Meeting Minutes

Riverwalk Planning, Design and Construction Committee

Tuesday, February 4, 2025

Comments on the Community Sign Concept

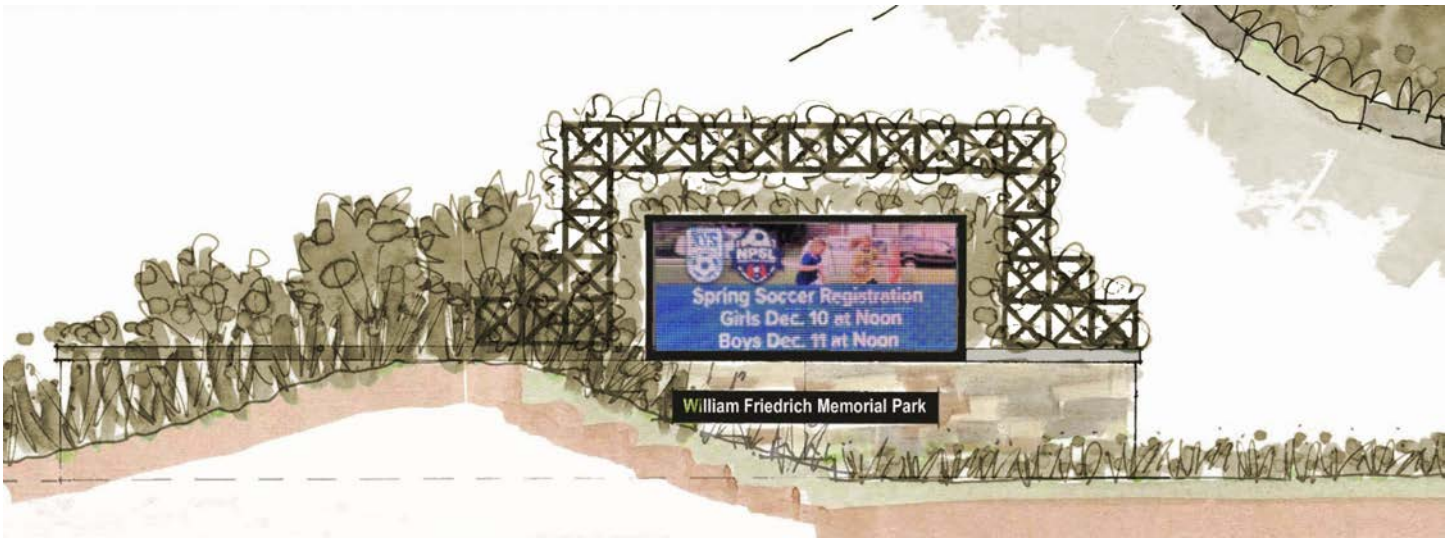
On the February 4, 2025 is a discussion of design of the community sign located along the South Extension of the Riverwalk. The proposal shows new landscaping, some berming, a trellis to surround the sign.

I realize it is difficult to make a digital sign look anything like, well, a digital sign, but I question the proposal. My thoughts are:

1. The digital sign must remain easily visible to vehicles and not have elements around it that may obscure the sign or distract drivers. Although climbing hydrangea need little pruning compared to other vining plants, it does produce wayward branches that could obscure the sign if not carefully maintained. Also, the proposed trellis is overpowering and utilitarian. It seems bulky and angular. I see no need for such added height. Also, the design will obscure the existing plaque mounted on the top of the wall.

2. I think how it will look year round, not just in summer. In winter, the utilitarian trellis will obtrude more. Please see the winter mock-up below.

4. This is a mock-up of the summer view. Please note, it is not a trellis. It also does not prohibit having a tree as an alternate landscape concept planted in the "v" of the wall.

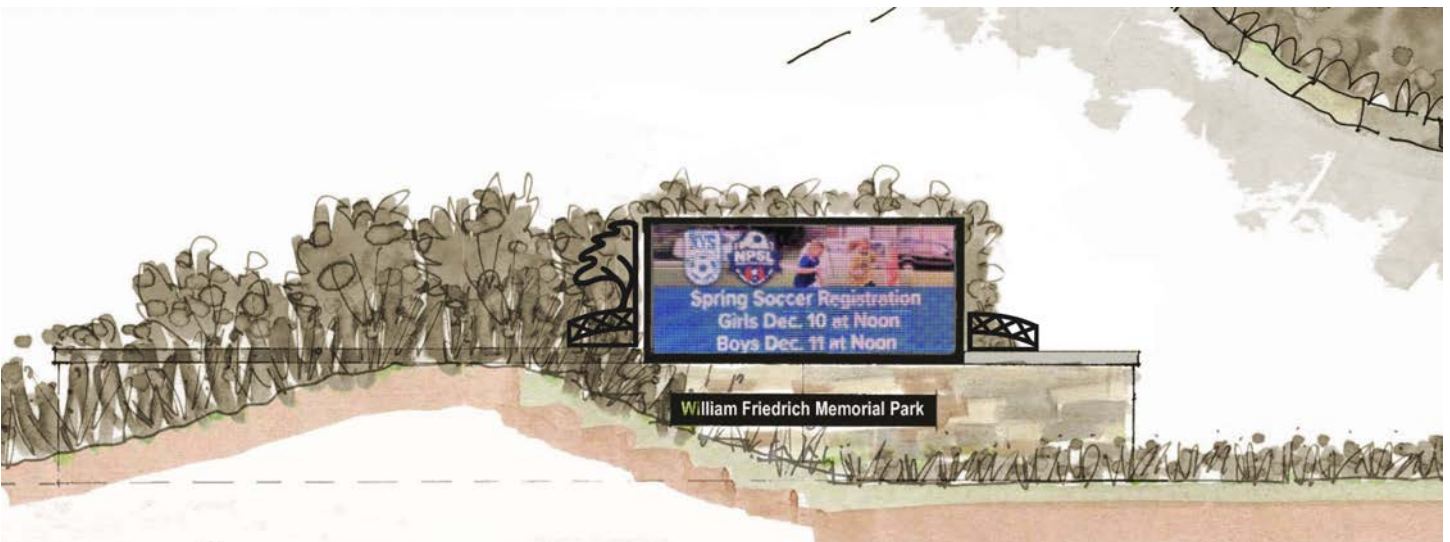
3. I'd prefer a softer design. Something without such hard edges and 90° angles. Something that does not add height. Something that does not interfere with plaque. Something that is low maintenance. Something that will not be so distracting to drivers who are trying to read the sign. Since it is Naperville Park District sign, one thought I had was to do something reminiscent of the park district logo. See below.
